Department of Transportation

MEMORANDUM

SUBJECT: ZC Case No. 24-21 – DC Correctional Treatment Facility Annex

Figure 1 | Site Circulation Plan

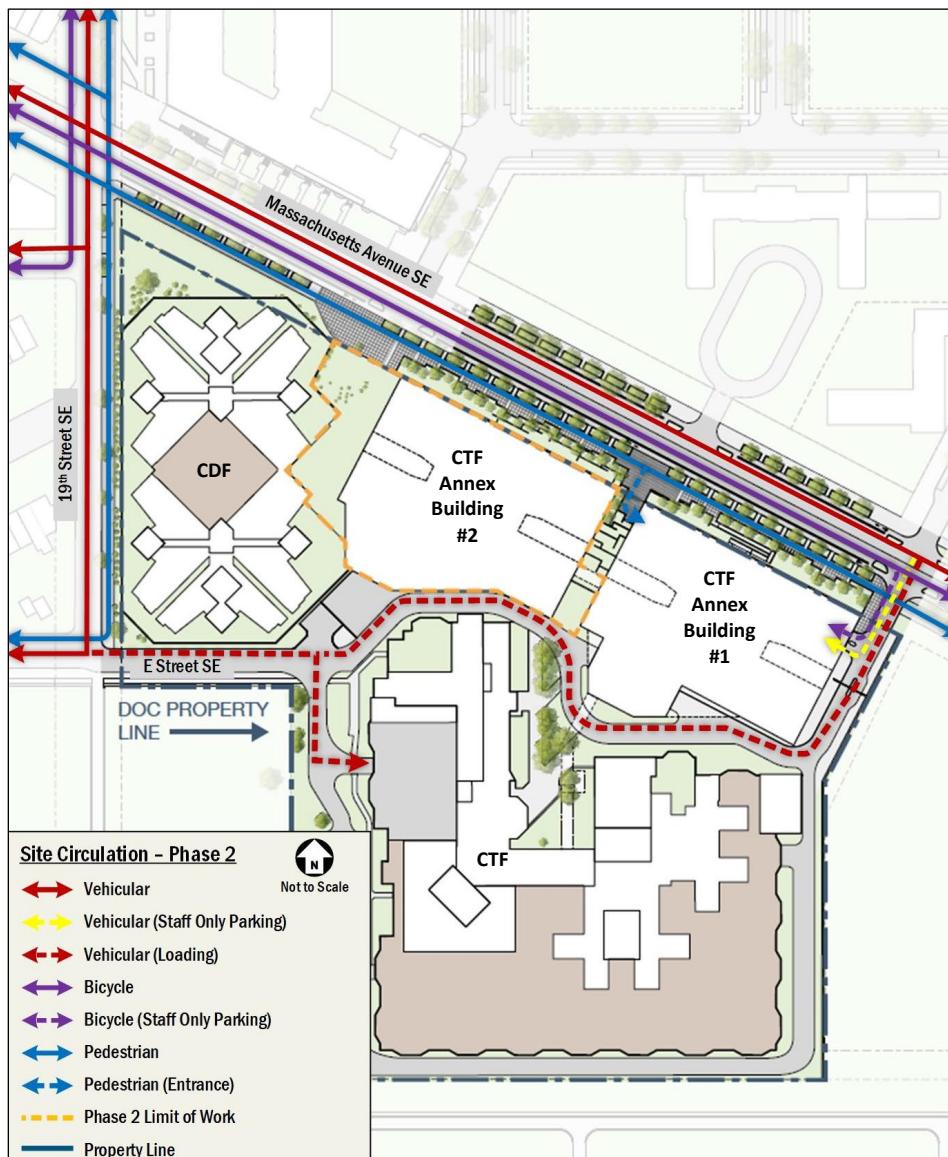
While the preliminary public space plans, shown in Figure 1, are generally consistent with DDOT standards, there are several considerations that need to be reviewed in greater detail during the IPMA-coordinated review process noted above:

- The design of the Massachusetts Avenue SE extension;
- All building entrances must be at grade with the sidewalk so that no stairs or ramps will be necessary in public space;
- Submit a detailed curbside management plan with proposed signage for review and approval by DDOT Curbside Management Division (CMD). If CMD requires multi-space meters for the remainder of the frontage, they will be at the Applicant's expense; and
- Determine final locations for the inverted-U bicycle racks.

Figure 6 | Proposed Curbside Designations

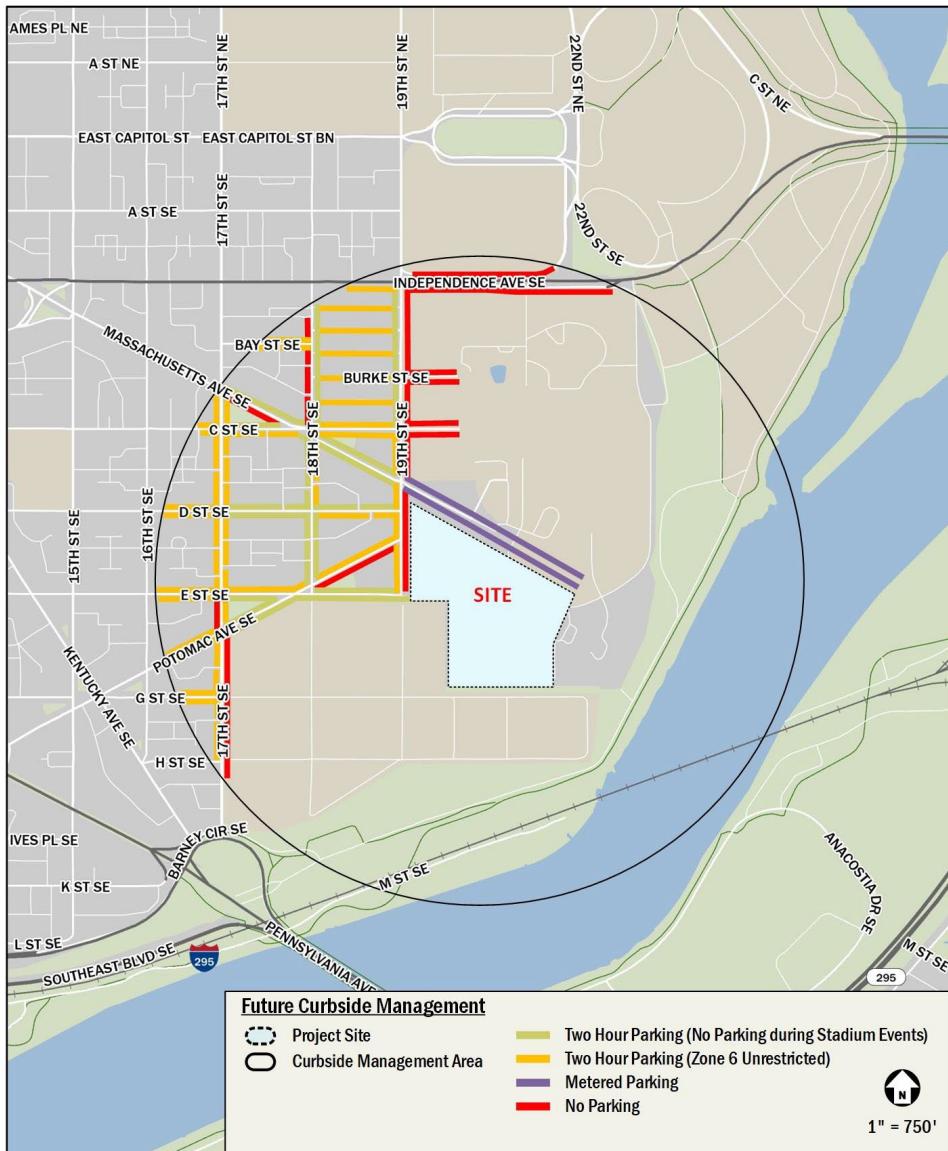
DDOT is generally supportive of this concept, however, a detailed curbside and signage plan must be included during the IPMA-coordinated Submittal, Review and Construction Acceptance process for Horizontal Development Projects and be approved by DDOT's Curbside Management Division (CMD). At that time, the plan may be refined by CMD and the exact signage placards will be determined. If multi-space meters are required by CMD then they will be at the Applicant's expense.
